Service Bulletin

No. : MZ07-053

Model: SR7400, SR8400

Subject: Software Update

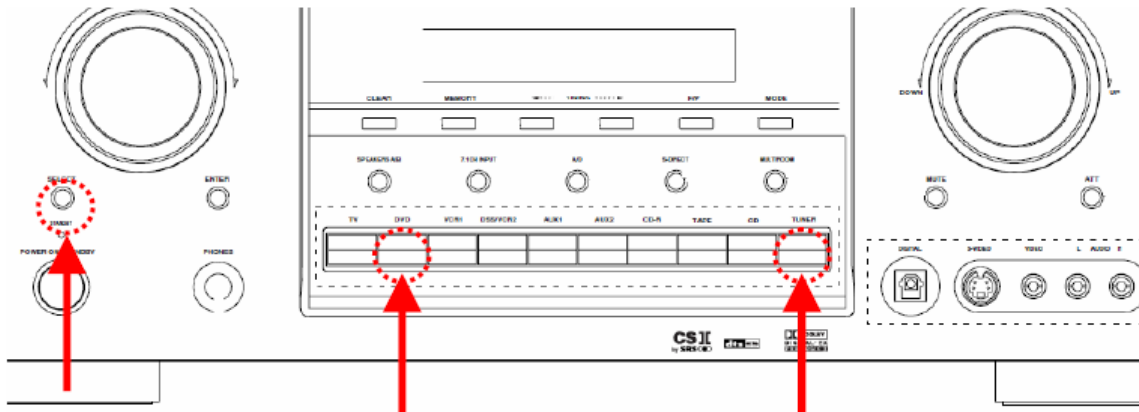
Before Updating:

Originally, the unit was designed to go into STANDBY mode with the STANDBY LED flickering every 500m sec. upon detection of an abnormality. The unit would never be powered on by the standby switch or the remote control, so over dissipation never occurred. However, if the unit was unplugged and plugged in again, component over dissipation could occur before the unit went into standby a few seconds later.

After Updating:

The unit has been modified never to be powered on by any means once it goes into standby with the standby led flickering every 125m sec., unless a specialized procedure (*1 described below) is performed.
